Chapel Hill East Condominium
Documents Relating to Construction Issues

Project: Chapel Hill East Condominium Association
7 Mount Hope Avenue
Providence, RI 02906

CONDITION ASSESSMENT REPORT

Figure 9

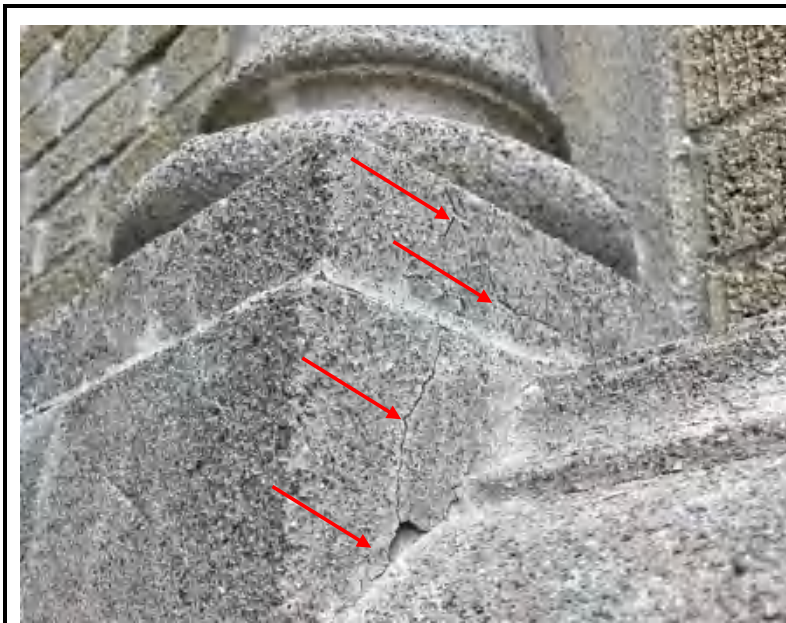
View of cracks in cast stone.

Figure 14

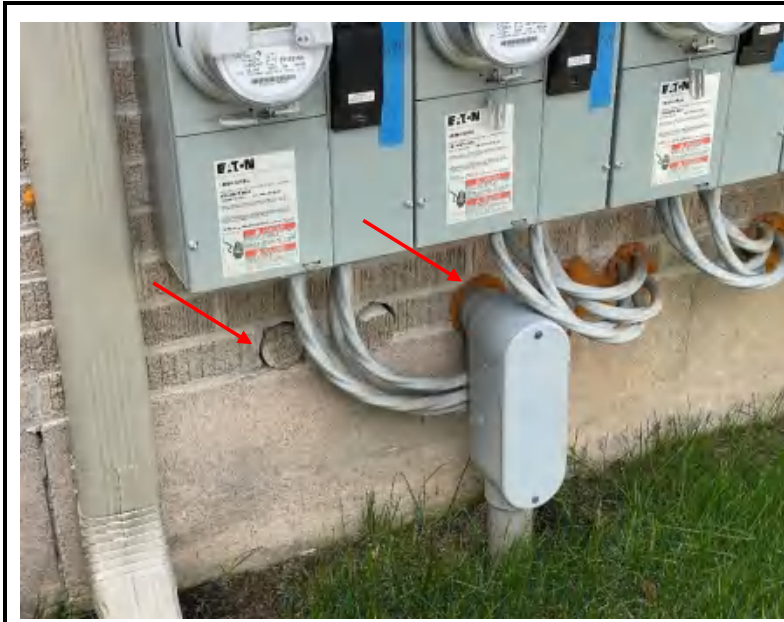
View of cracks in masonry wall. Spalled cast stone with failed mortar joint also seen here.

Figure 19

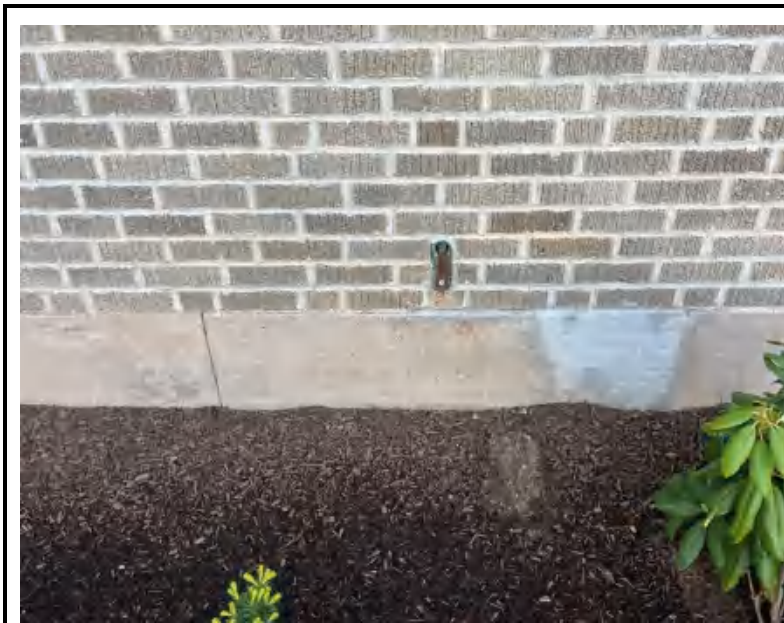
View of spalls in the individual cast stone foundation units.

Figure 20

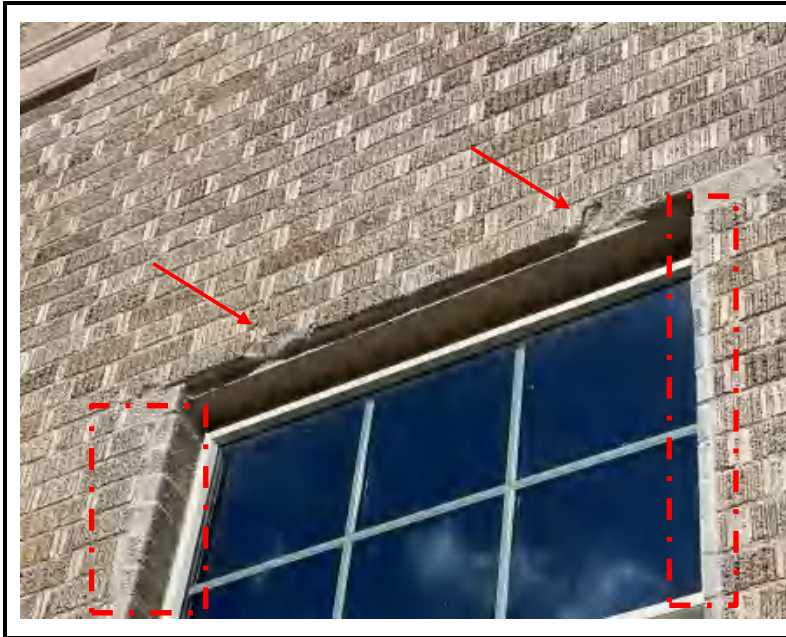
View of attempted repair in cast stone foundation.

Figure 21

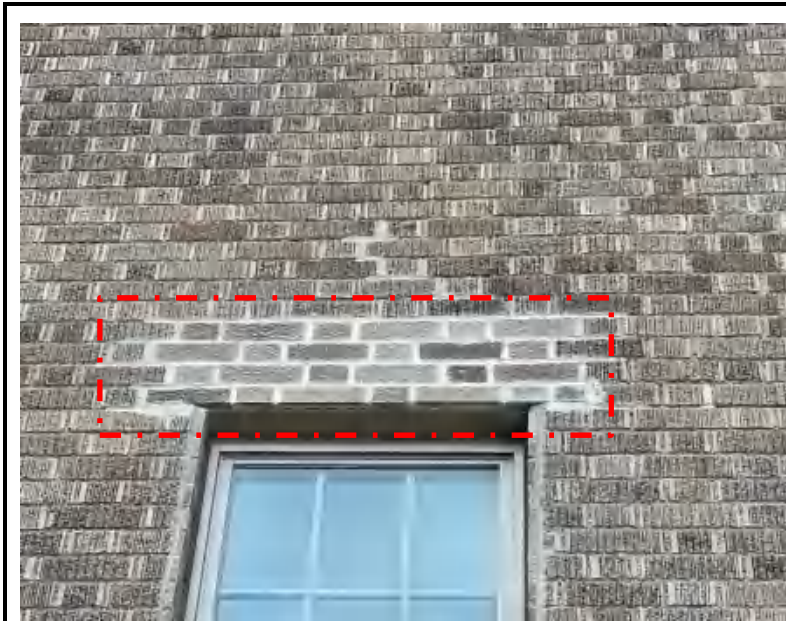
View of spalls in individual brick masonry units above the window lintel. Brick segment infills at the window rough opening also seen here.

Figure 22

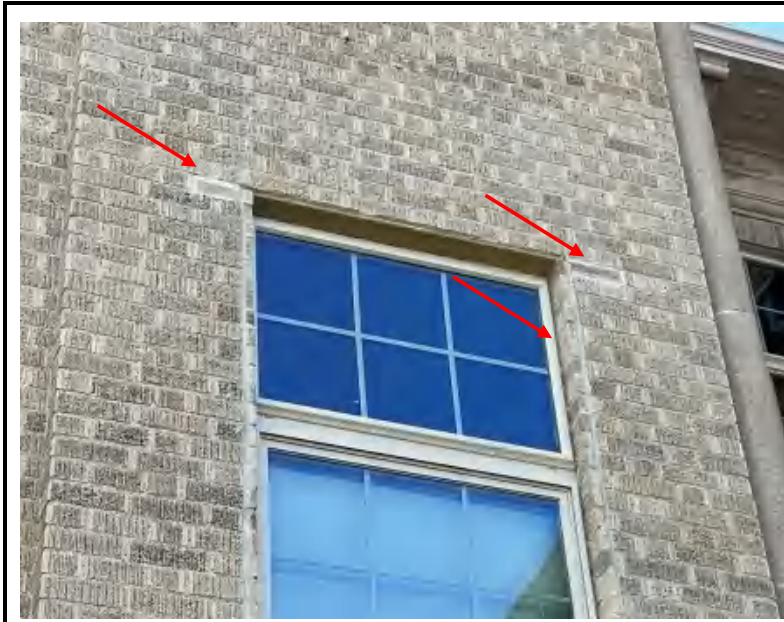
View of previously repaired or replaced brick at the window lintel.

Figure 29

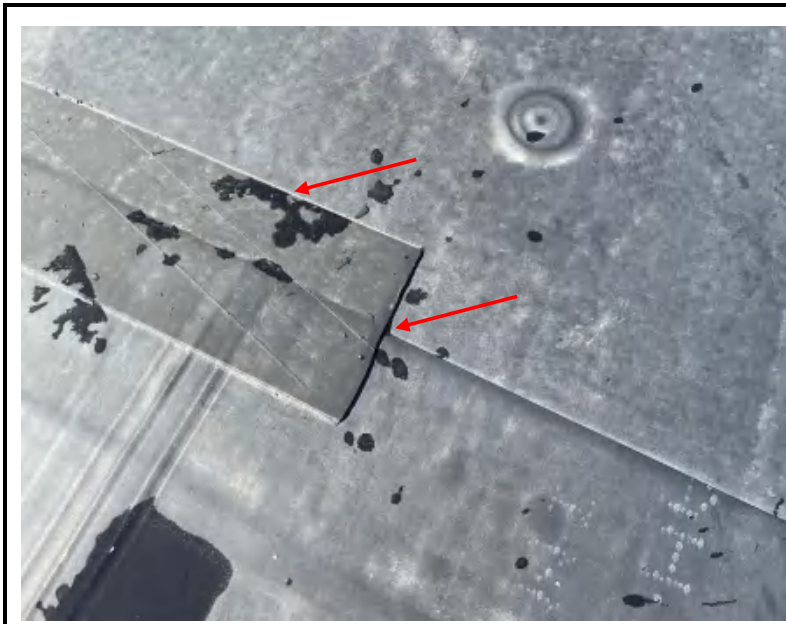
View of mechanical insulation fastener pushing on backside of EPDM roof membrane.

Figure 30

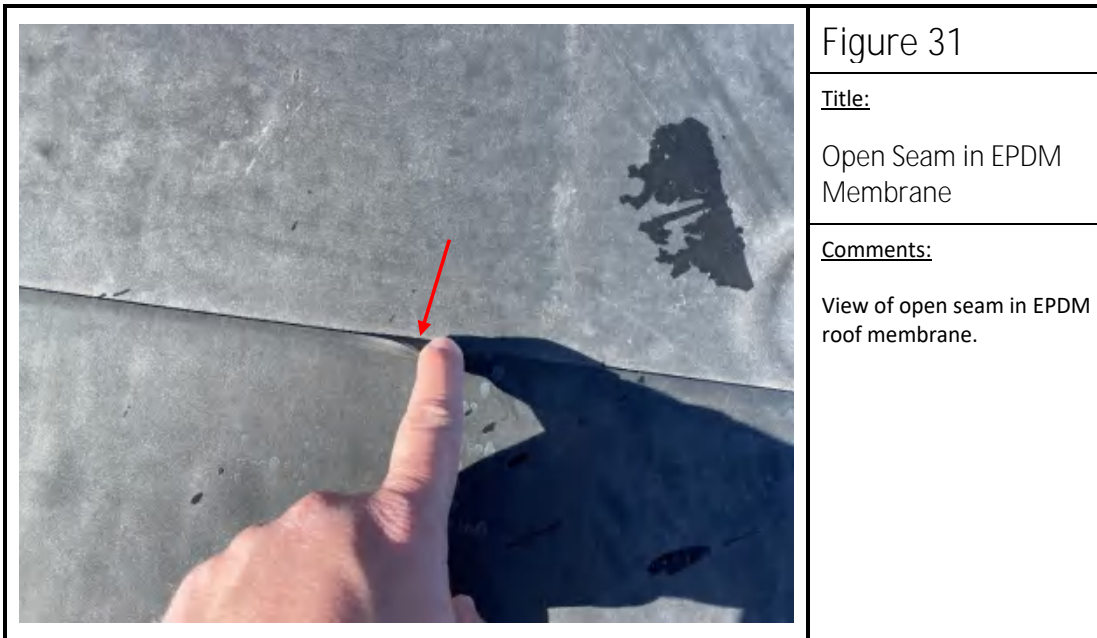
View of EPDM seam strip that has not been properly terminated.

Figure 53

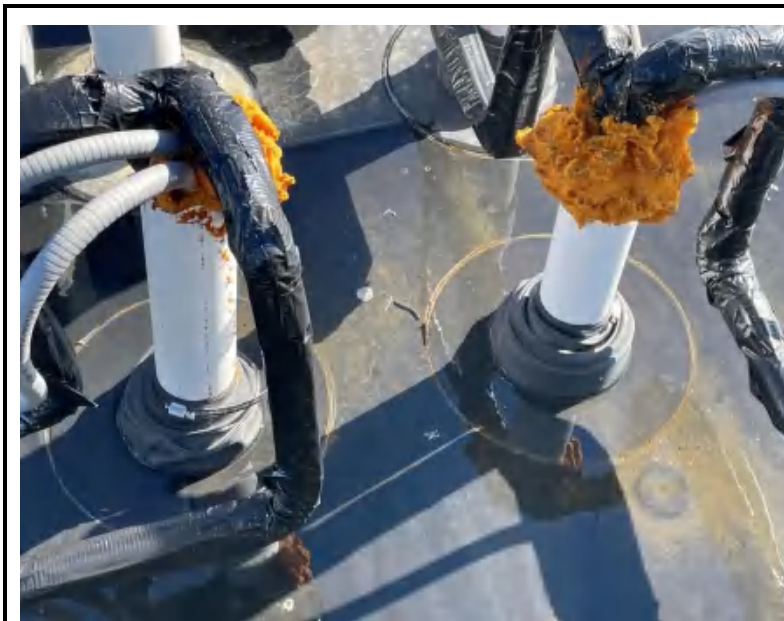
View of roof penetrations improperly filled with foam rather than a pitch pocket or approved flashing. The PVC pipe is not fastened or secured below. The boot flashing has collapsed. The PVC pipe is being pulled down by the weight of the pipe and the conduit.

Figure 56

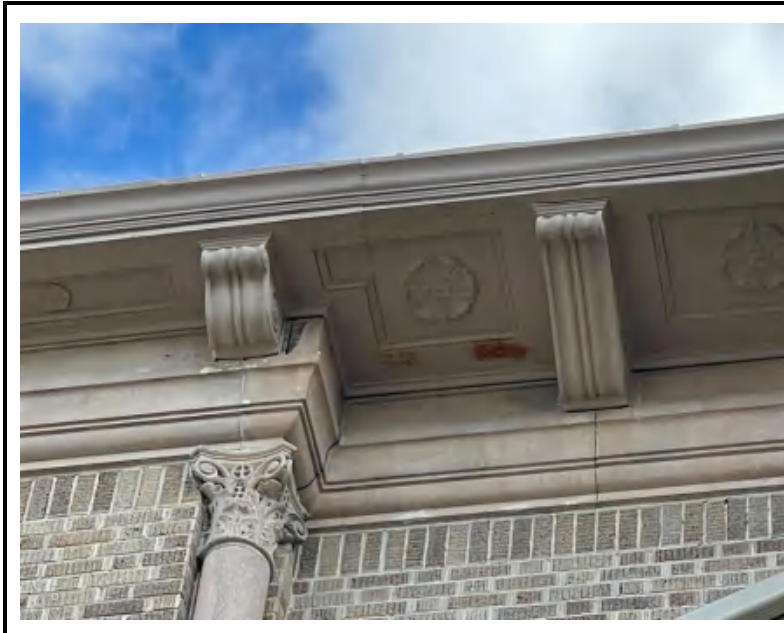
Partial view of roof field, with ponding around internal roof drain.

Figure 60

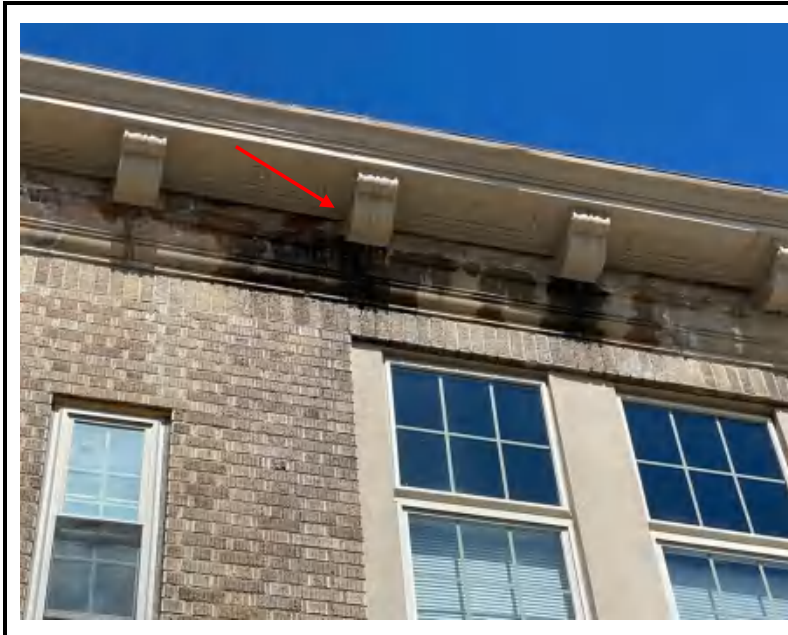
Severe deterioration of the cast stone has resulted from reported and documented water leaks above the front entrance at the roof level.

ISSUE 3

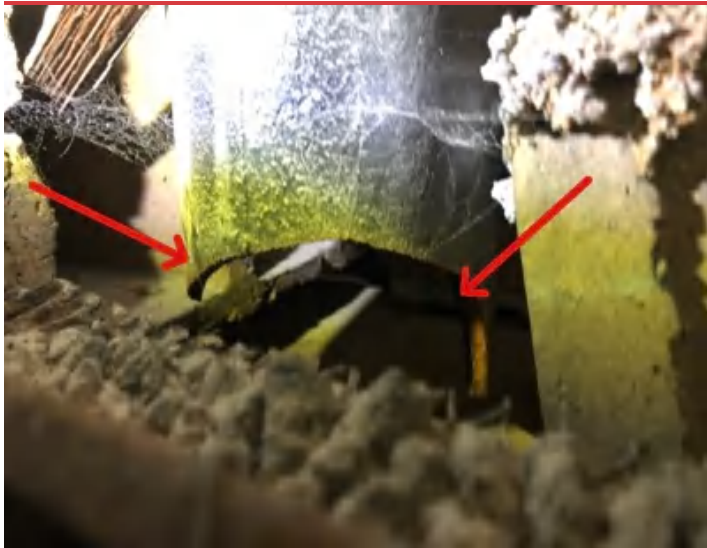
View from roof of old cast vent. Notice the holes along side of vent.

Same cast vent from inside

ISSUE 16

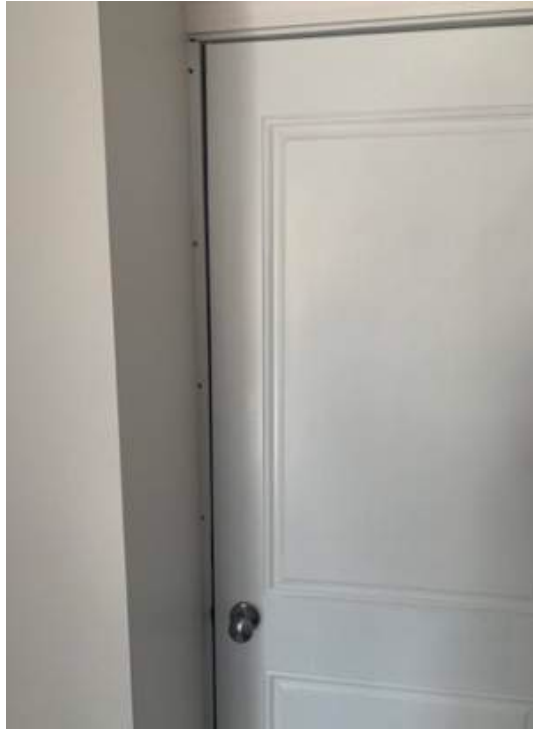
Bathroom door needs a
doorstop in community
room. Wall will get
damaged

Done

ISSUE 33

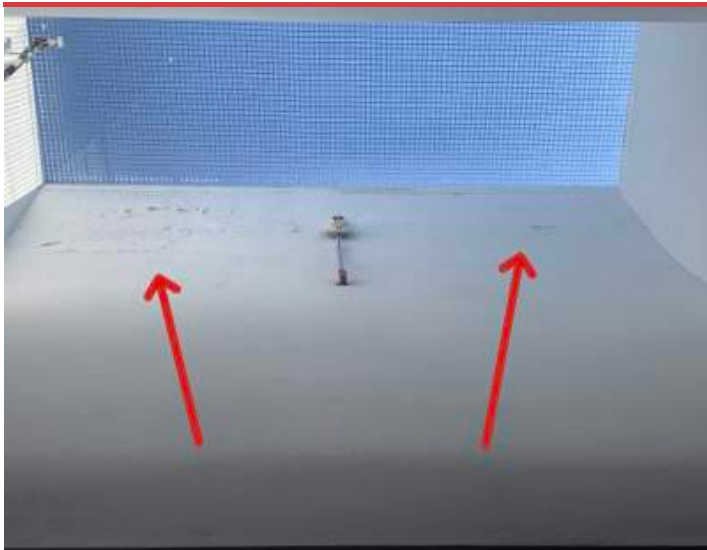
More wall repairs. See 32.

Done

ISSUE 65

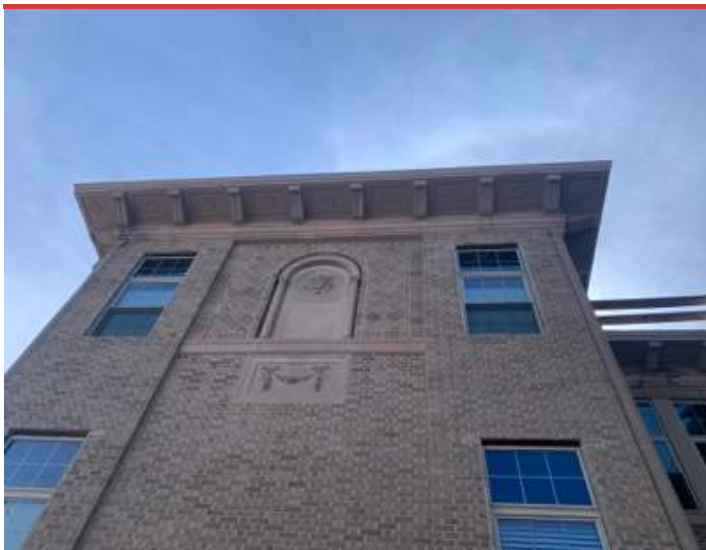
Railing system needs to be bolted to the ground and bolts need to be cut with a grinder so that they are not protruding. All needs to be painted with rust preventative type product.

Not done.
